Confederation of Indian Industry

Inputs/suggestions from stakeholders on the Draft Notification No RA -14026/(11)/1/2023-CERC vide public notice dated 17.2.024

Clause wise comments

Fig. 4-1 Stoker Capacity Diagram

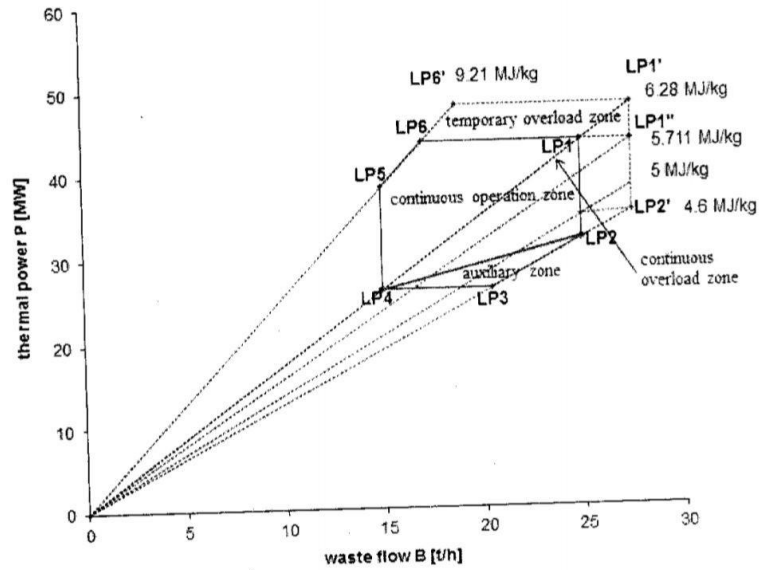
- (iii) The design basis /firing principle for these waste fired boilers entail a range of heat value usually ranging from 1100 Kcal/kg to 1900 Kcal/kg. The design point is the upper value of heat value , and the corresponding capacity sizing of the electricity generation, though the installed capacity of electricity is often is not realized for at least half life of the project. A sample firing diagram is as under
